REACTIVITY CONTROL SYSTEMS

SHUTDOWN MARGIN - K_{N-1} - ANY CEA WITHDRAWN

8911150089 891106
PDR ADOCK 05000529
P PDC

FIGURE 3.1-4

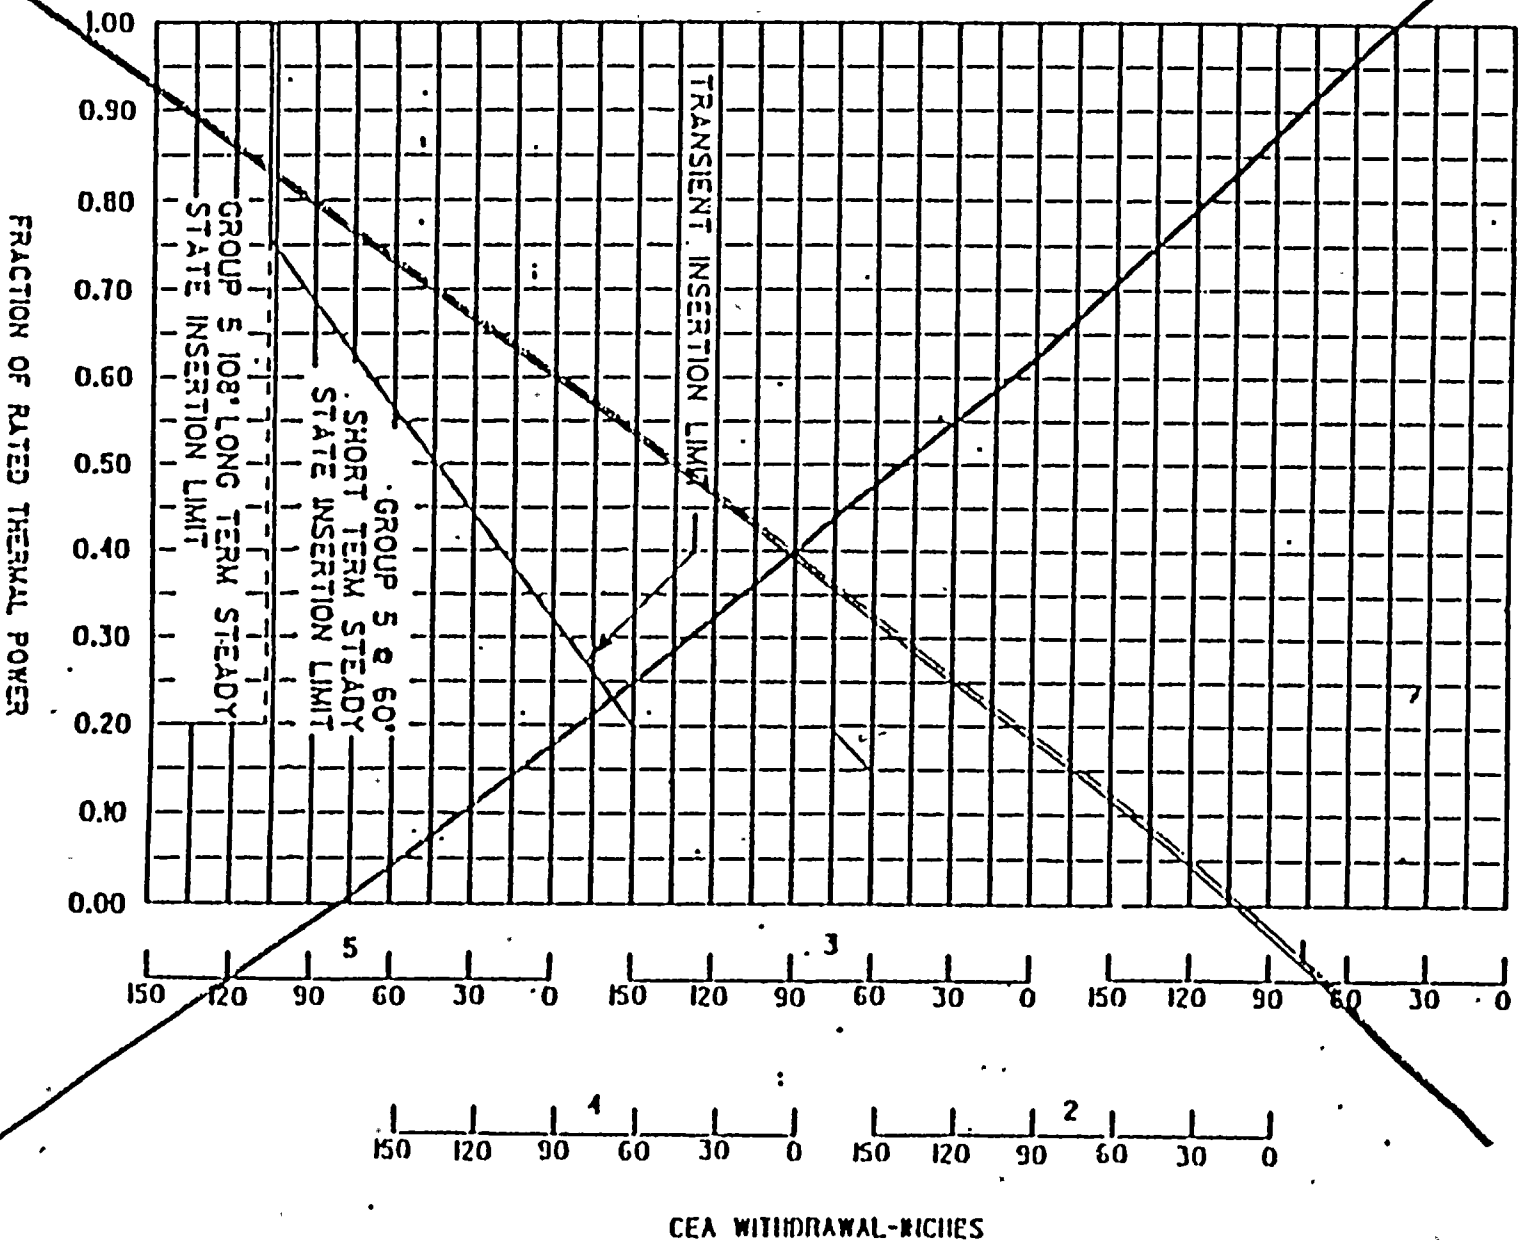
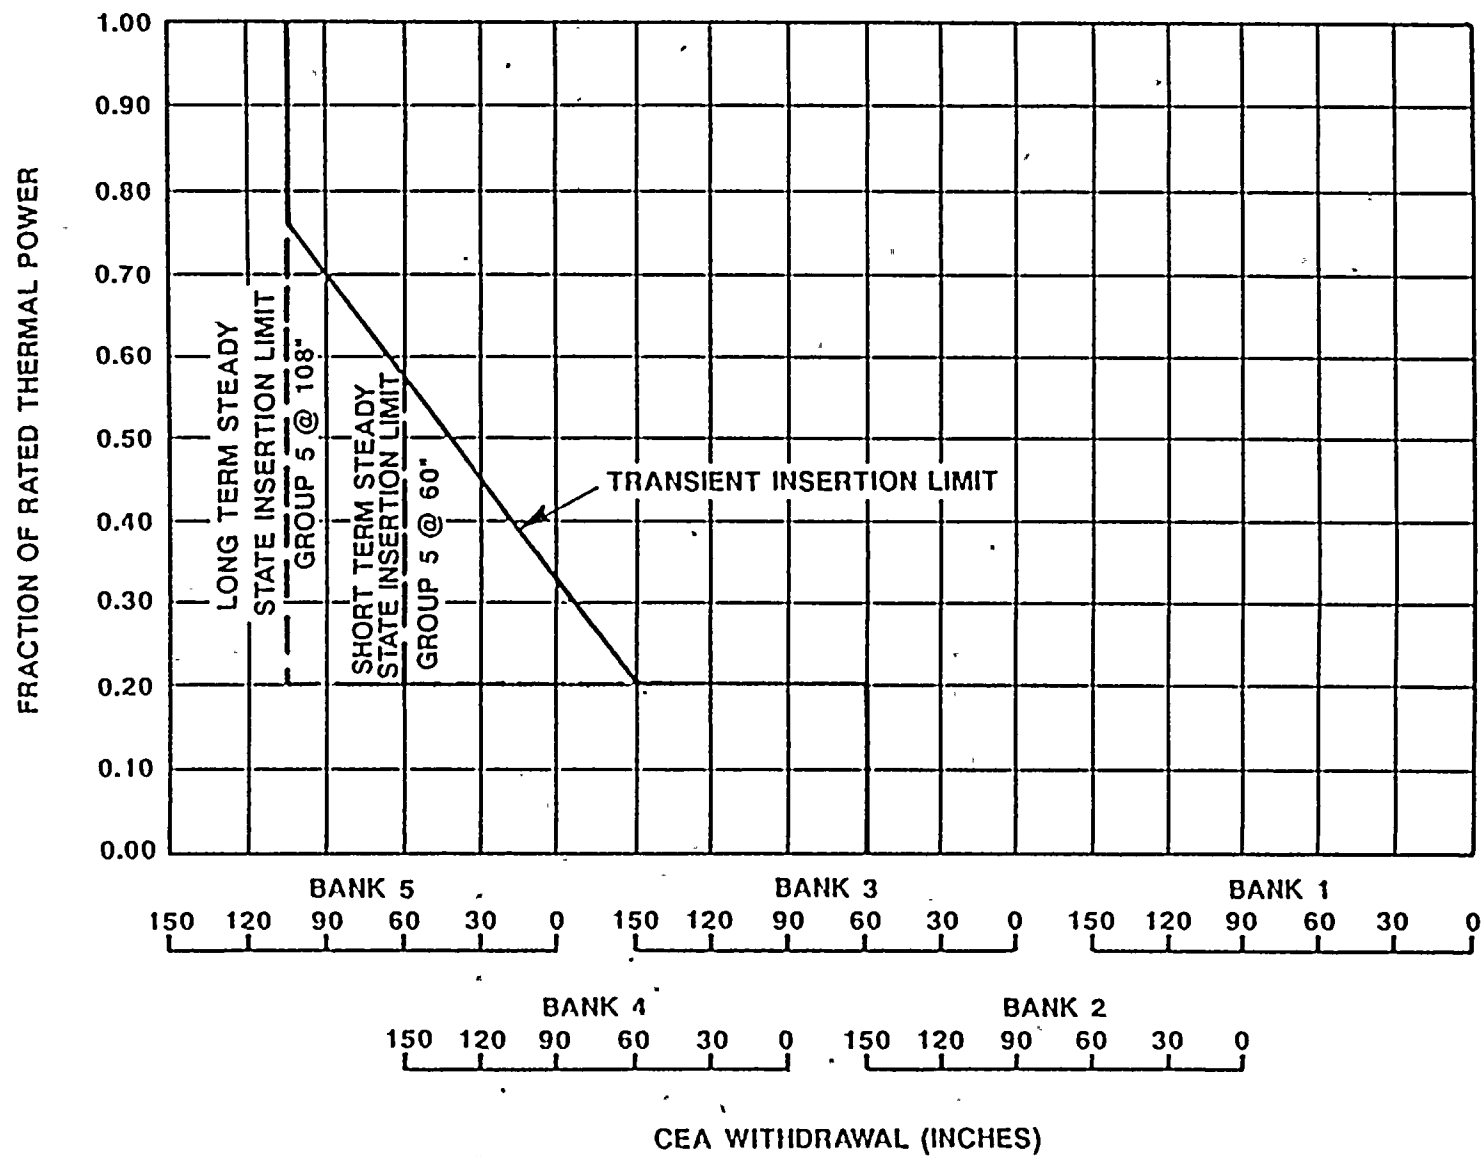
Replace with
New Figure 3.1-4
